Preview Solution CBR-2540-1

Upper Bunk Restraint System – Plastic Gable Retention Field Fix

Published 19 December 2025

Cross-sectional view indicating the required screw fastening locations.

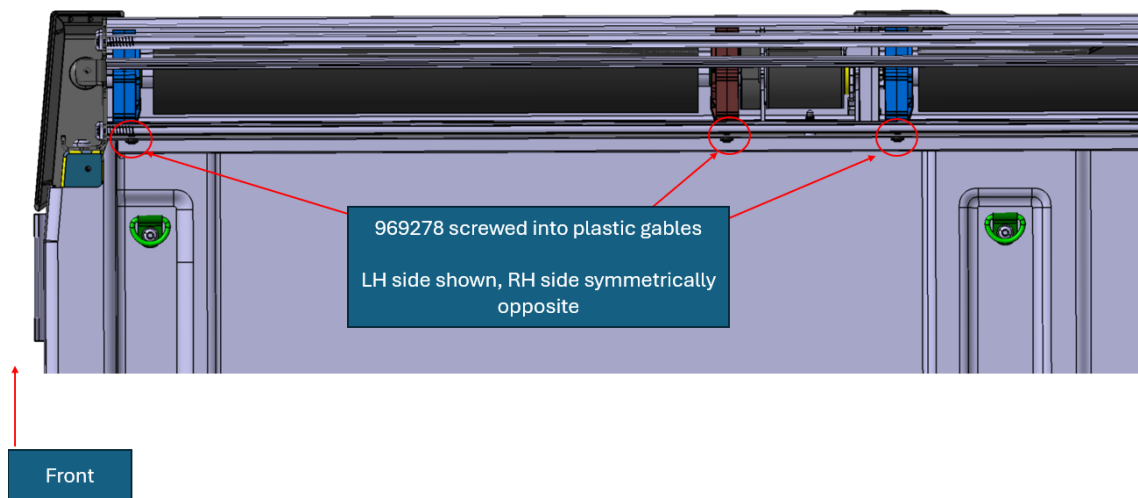
- Mark centerline of each plastic gable using masking tape.
- Measure approximately 10 mm from the back flange of the restraint. Do not exceed this measurement.
- Drill pilot hole if needed (do not exceed 1/8 in bit).
- Work from one end to the opposite end to prevent gable shift.

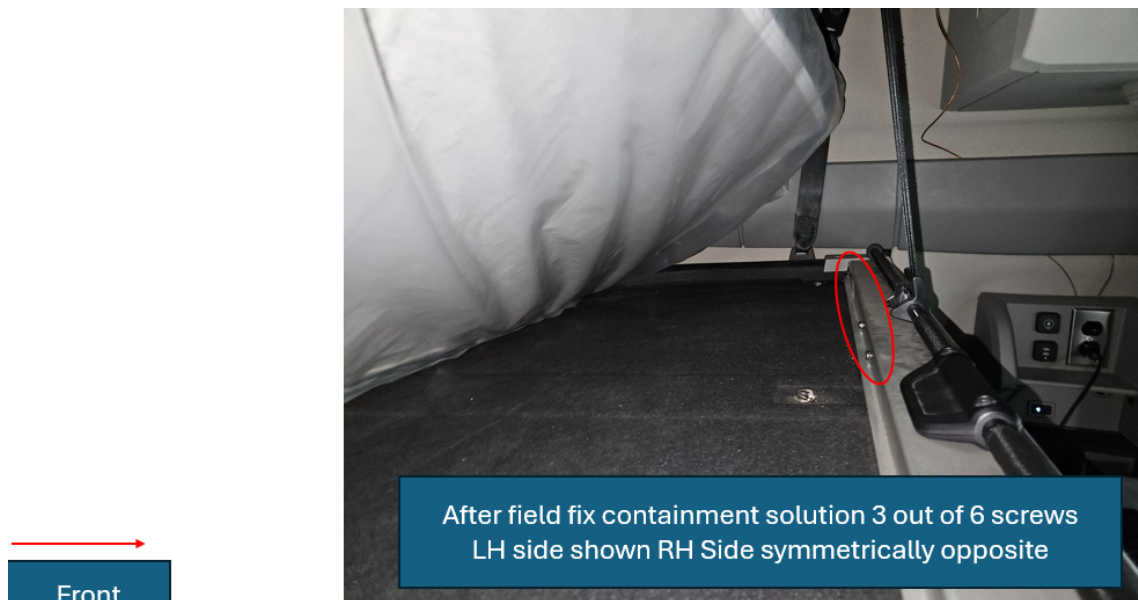
- Drill through aluminum restraint and plastic gable.

- Maximum drill depth: 0.5 in.
- Install screw 969278 into each plastic gable.
- LH side shown; RH side is symmetrical.
